Access Compliance Report

Public Rights-of-Way (Curb Ramps)

Intersection ID: 10025795	Main Street: EDGEHILL_RD_NORTH	Cross Street: N/A	Location: NE
ADA ID: 2F61182FFA78	Ramp Type: Directional1	Initial Pass/Fail: Fail	Overall Compliance: No
Severity Score: 46.25			
Codes/Mitigation Info/Possible Solution		Field Measurements/Component Compliance

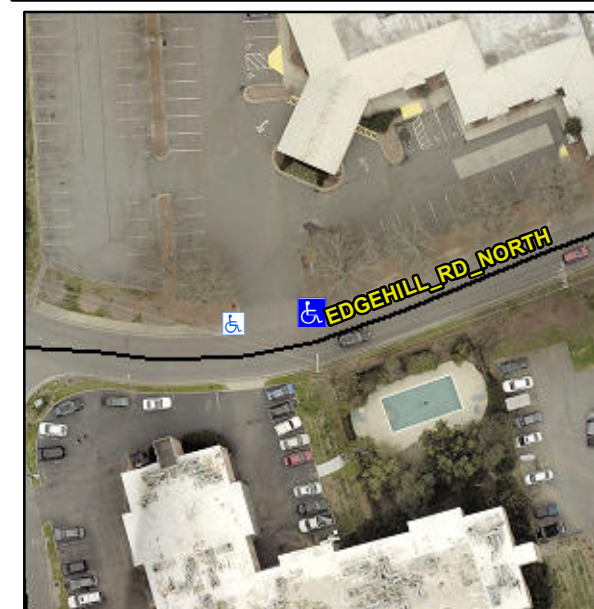
R304.5.1, R304.2.2, R304.5.3

Compliance	Description	Data	Compliance	Description	Data
N/A	Ramp Length (in)	20.0	N/A	Grade Break?	N/A
No	Ramp Width (in)	45.0	N/A	Grade Break Slope (%)	0.0
No	Ramp Slope (%)	18.5	N/A	Grade Break XSlope (%)	0.0
No	Ramp XSlope (%)	5.6			
N/A	Flare Type LT	N/A	N/A	Flare Type RT	N/A
N/A	Flare Slope LT (%)	N/A	N/A	Flare Slope RT (%)	0.0
N/A	Flare Traversable LT?	N/A	N/A	Flare Traversable RT?	N/A
N/A	Landing Length (in)	0.0	N/A	DWS Provided?	N/A
N/A	Landing Width (in)	0.0	N/A	DWS Contrast?	N/A
N/A	Landing Slope (%)	0.0	N/A	DWS Length (in)	N/A
N/A	Landing X Slope (%)	0.0	N/A	DWS Full Width?	N/A
N/A	Landing Curb? (Y/N)	N/A	N/A	DWS Offset LT (in)	N/A
N/A	Shared Landing?	N/A	N/A	DWS Offset RT (in)	N/A
N/A	Gutter Ponding?	0.0	N/A	Gutter Slope (%)	N/A
N/A	Gutter Lip Ht (in)	0.0	N/A	Gutter X Slope (%)	N/A
N/A	Painted X Walk1?	No		Road Slope (%)	3.6
	X Walk 1 Direction	To SW		Road X Slope (%)	3.5
	X Walk 1 Width (in)	N/A		Clear Space?	N/A

Remove & Replace Entire Ramp.
